INSTALLATION OF CUSHION BARRIER
AT LUNALILO FRWY - VINEYARD (OFF-RAMP)
& STA. 83+00
SAFETY IMPROVEMENTS ALONG
INTERSTATE H-1
KALIHI ST. TO PALI HIGHWAY
Proj. No. I-HI-1(112):19 Date: April, 1973

STATE OF HAWAII
DEPARTMENT OF TRANSPORTATION
HIGHWAYS DIVISION
INSTALLATION OF CUSHION BARRIER
AT LUNALILO FRWY. & RAMP "5"
@ Sta. 103+50
SAFETY IMPROVEMENTS ALONG
INTERSTATE H-1
KALIHI ST. TO PALI HIGHWAY
Proj. No. I-H-1(112)19 DATE: April, 1973

C. O. 45

SAFETY IMPROVEMENTS ALONG
INTERSTATE H-1
KALIHI ST. TO PALI HIGHWAY

SECTION B-60
Scale: 1/4" = 1'-0"

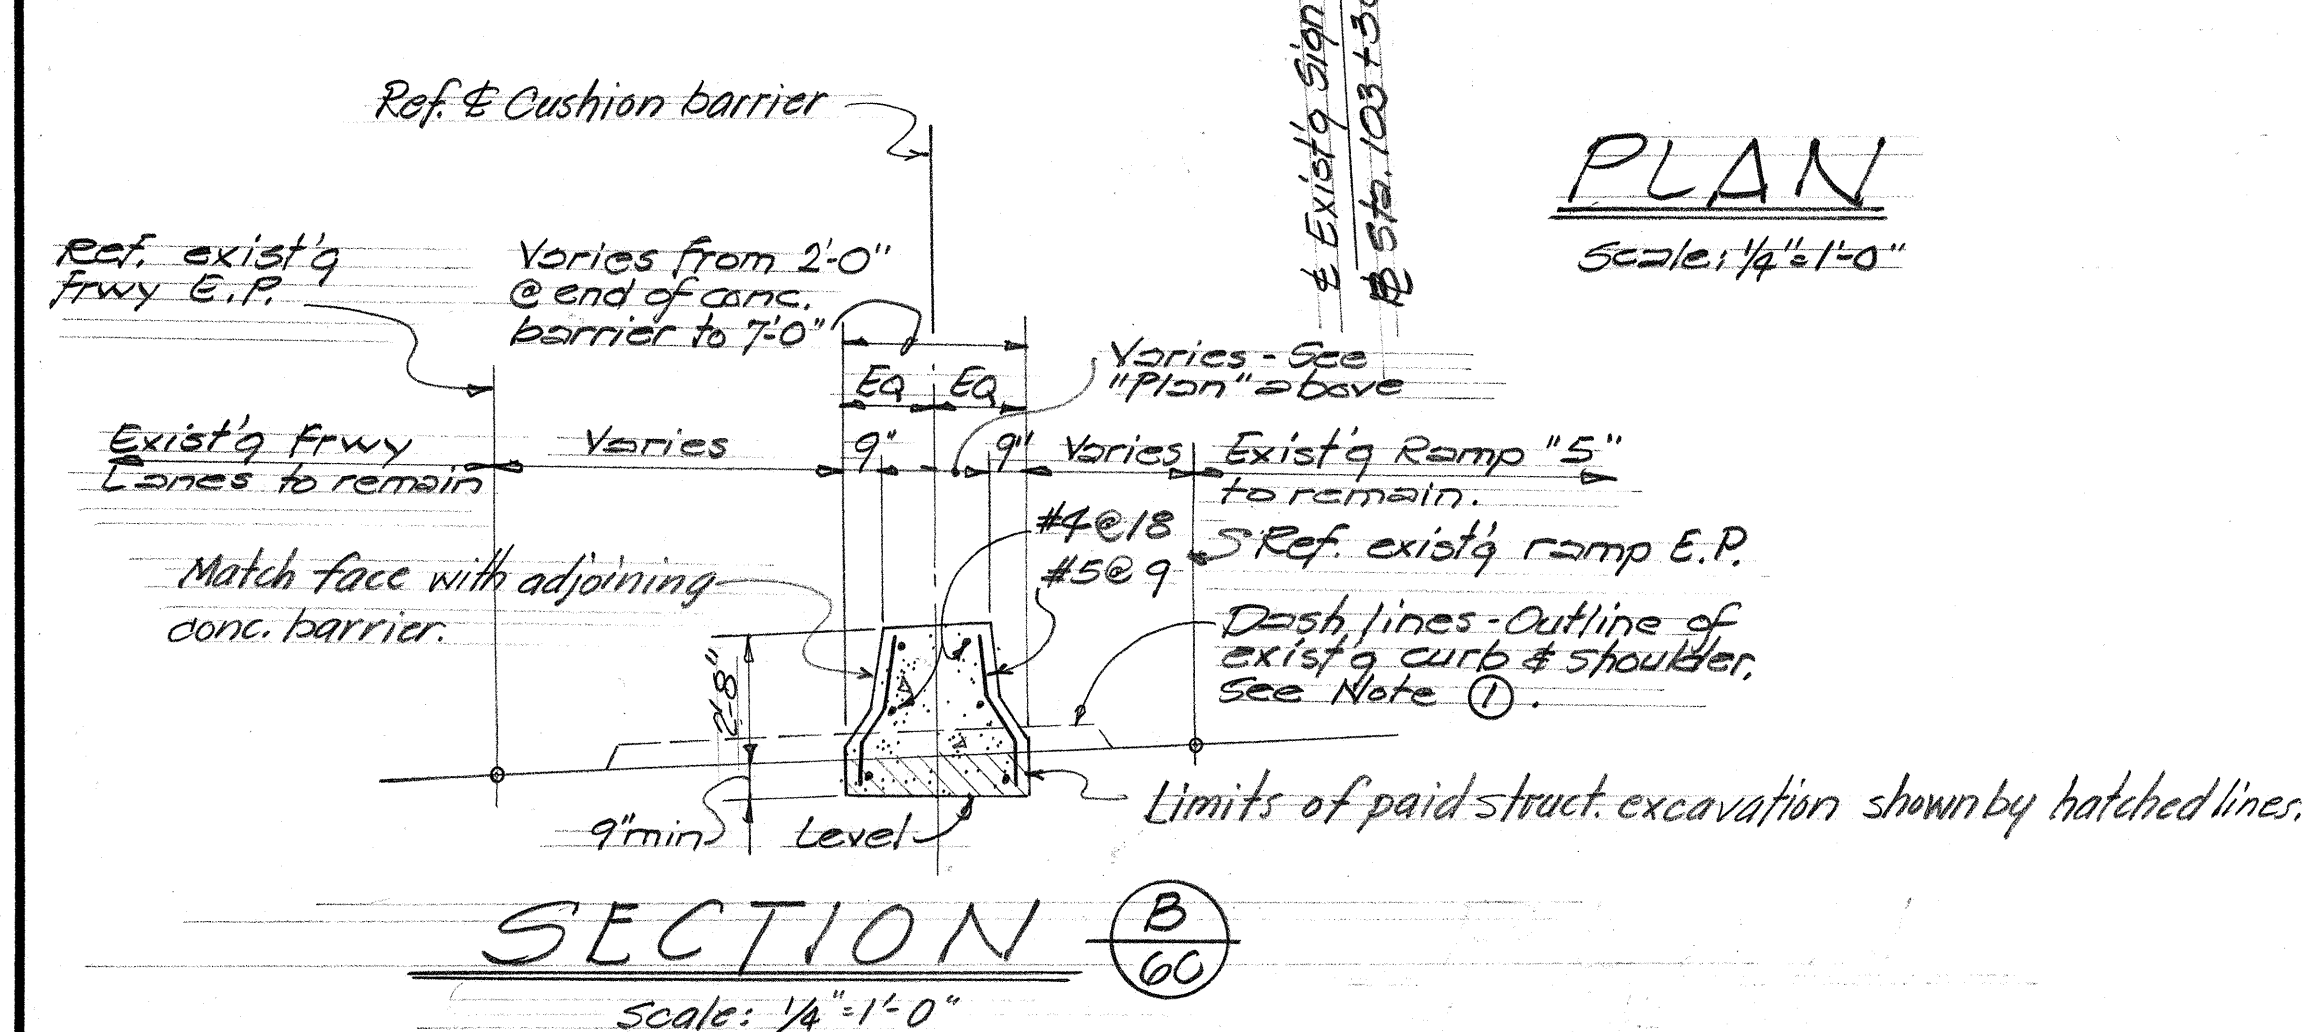
12'-6-74 Height of 2" pipe sleeve changed from 1'-8" to 1'-8 1/2" and length of unit changed from 21'-2 1/4" to 19'-11 1/2".

SHEET No. 7C OF 11C SHEETS

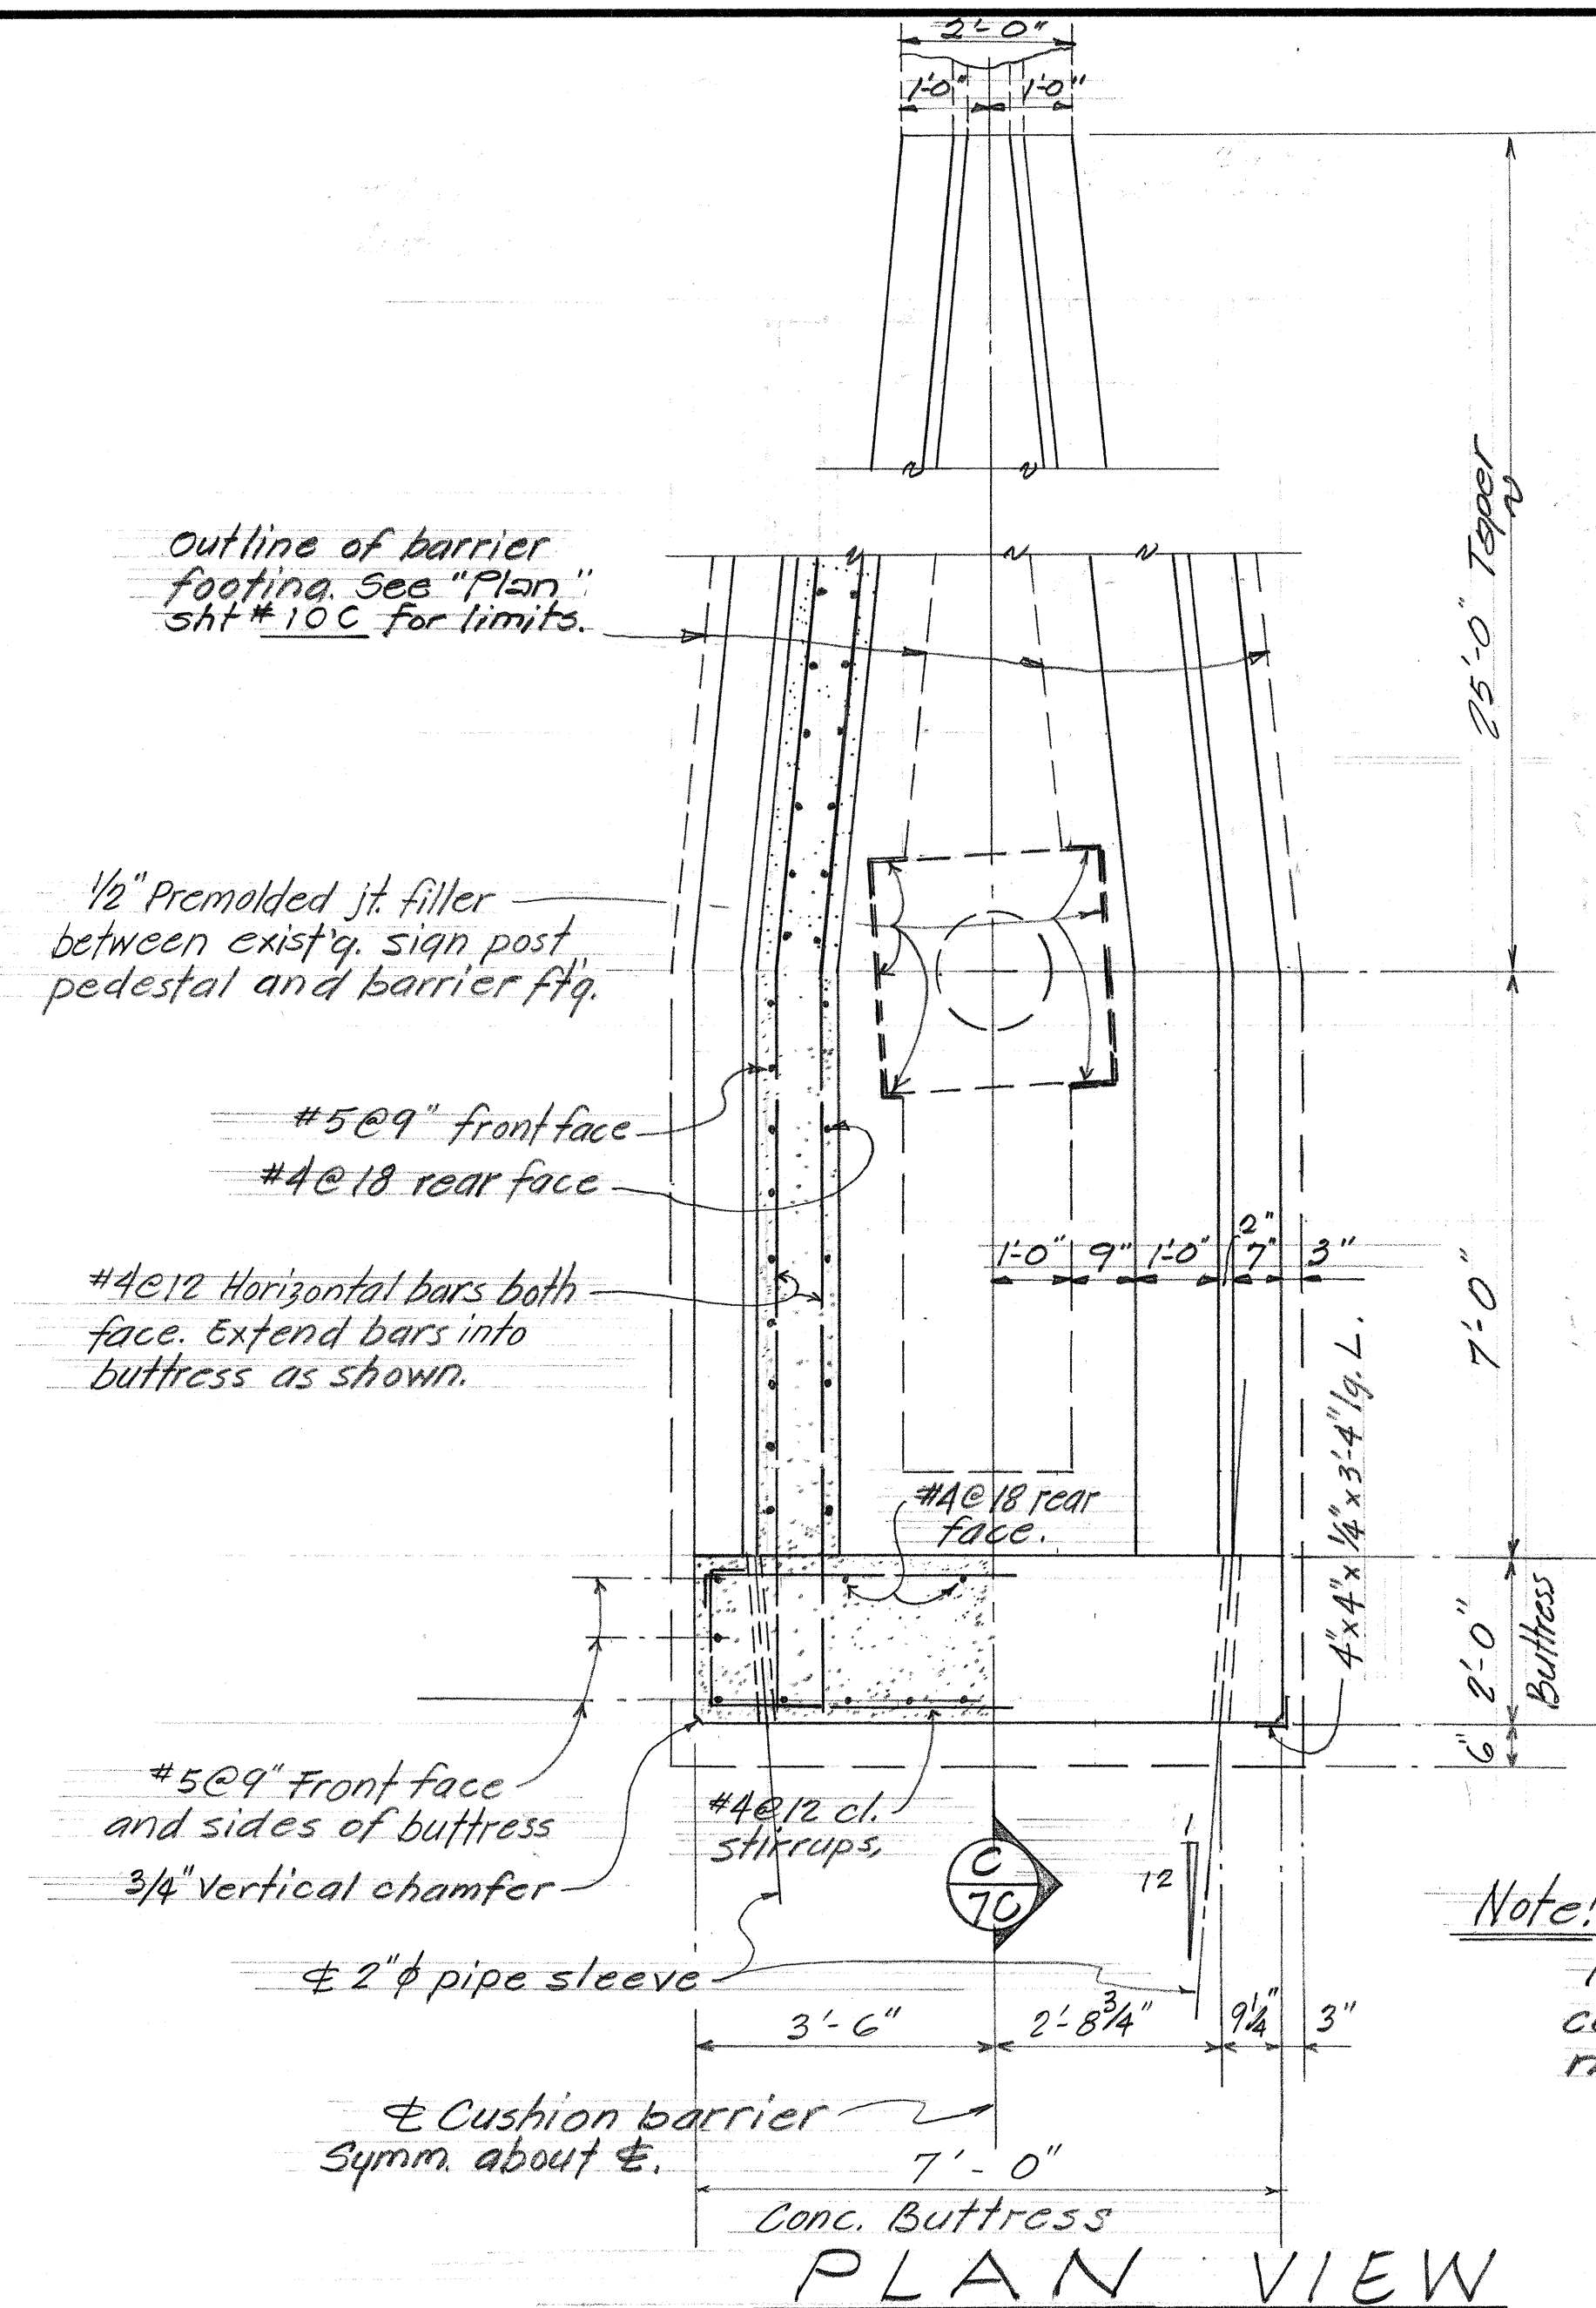
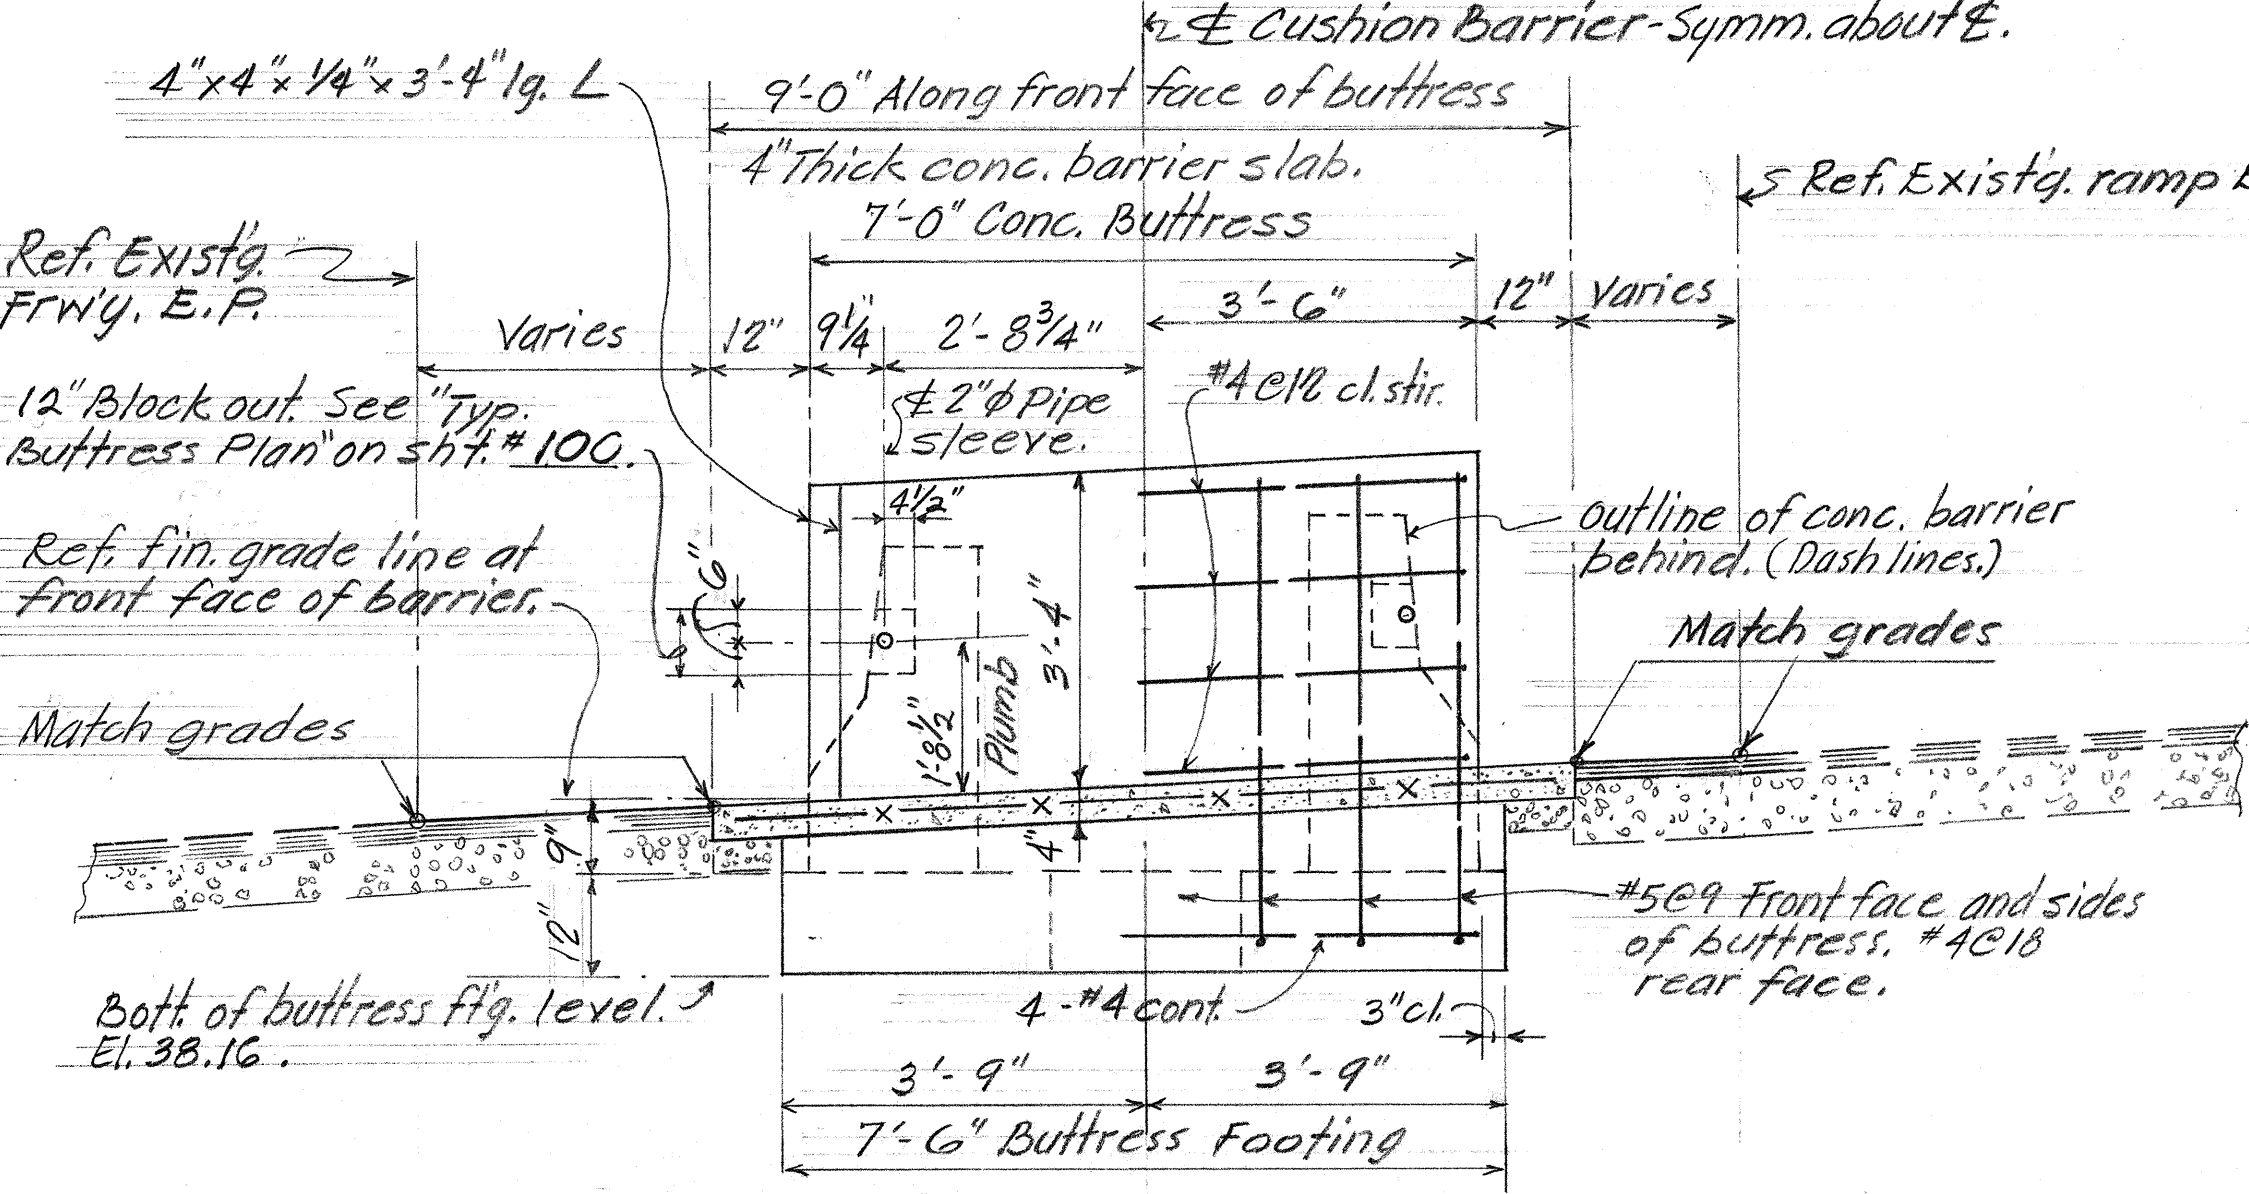
12-6-74 Restraining cable 2" pipe sleeve dimension changed from 2'-8 1/4" to 2'-8 3/4" and block out dimension revised. Length of unit changed from 21'-2 1/4" to 19'-11 1/2".
